#### Comment #1:

## Attachment 1

# Attachment 2

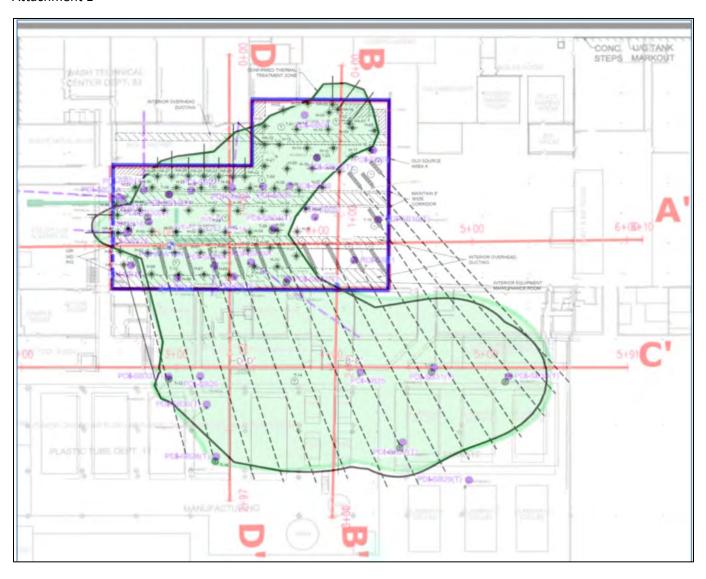
EVS model, 4DIM file: As part of the RAWP, for Cluster 5, can the angle of the clusters be adjusted such that there is more heater coverage on the outer extent of the projected TCE volume? Reference Attachment 2.
